# Site Accessibility Evaluation

### **Costilla Parking Garage**

**Accessibility Evaluation**

***Inspection Date: 08/05/2019***

Finding 297249 Main Photo

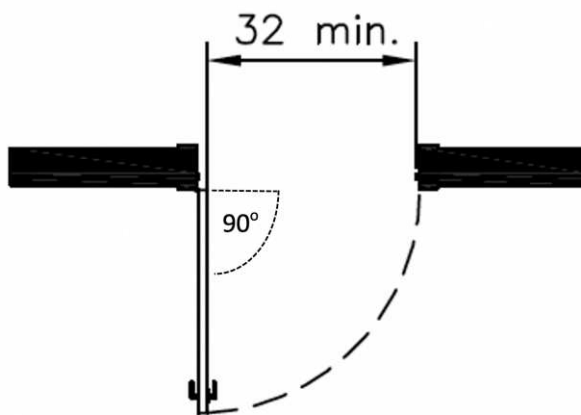
The door opening does not provide at least 32 inches between the face of the door and the opposite stop.

25.25 inches in width.  
Door located on  
northeast corner of  
Tejon and Costilla

Install door frame and door that provides a minimum width of 32 inches. Projections into the clear opening width between 34 inches and 80 inches above the finish floor or ground shall not exceed 4 inches.

CORRECTED

Finding 297250 Main Photo

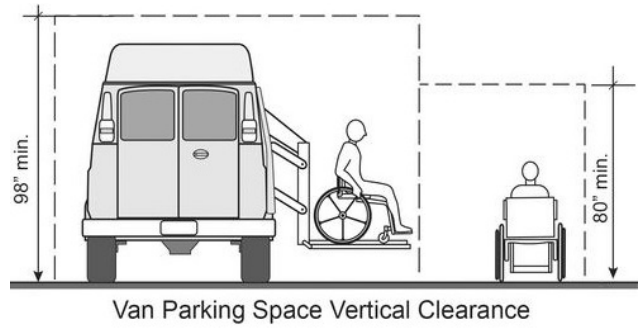
The vehicle route to the accessible parking contains vertical clearances less than 98 inches.

Parking structure  
height clearance  
maximum is 86 inches

At the moment there are no plans in constructing a new structure. Will address ADA parking to the maximum extent possible for compliance.

TECHNICALLY  
INFEASIBLE

Finding #4 Continued

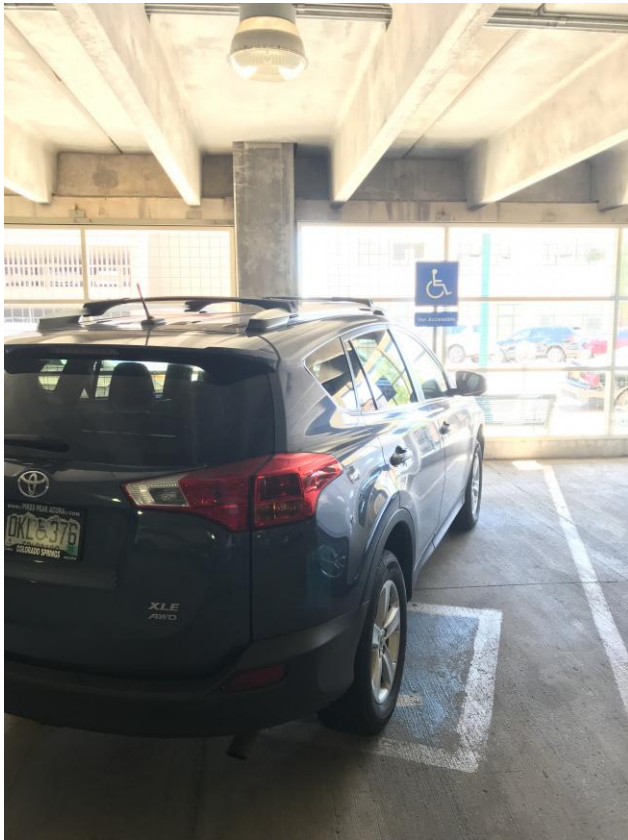
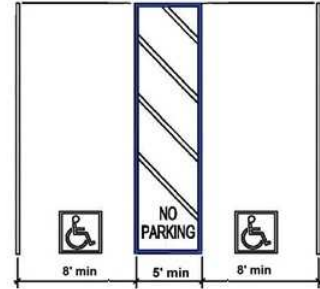
The access aisle is missing at the accessible parking stall.

Access aisle missing  
for 2nd accessible van  
parking stall

Re-configure striping to ensure 2 van stalls with 2 access aisles to the right of each van stall and 7 accessible parking stalls with a 5 foot access aisle. Since parking stalls are angled, each van stall must have its own access aisle located on the passenger side. Non-van accessible stalls may share an access aisle or van access isle and access may be located on either side of the vehicle.

CORRECTED

Finding 297287 Main Photo

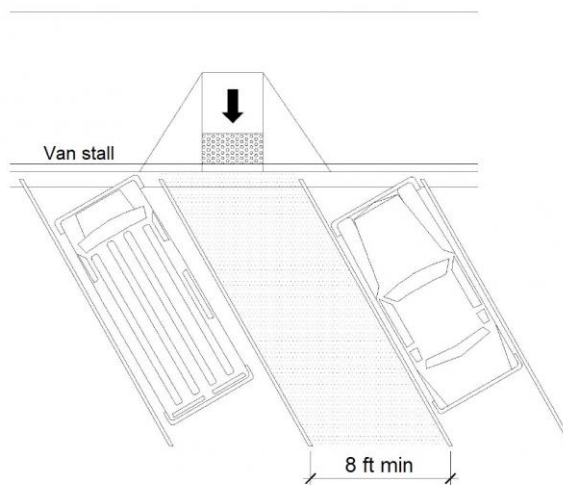
The access aisle is on the driver's side of the stall.

Access aisle on driver's side (angled parking stall)

Remove "van accessible" signage from 2nd stall. Van access aisles must be on passenger side for angled parking stalls.
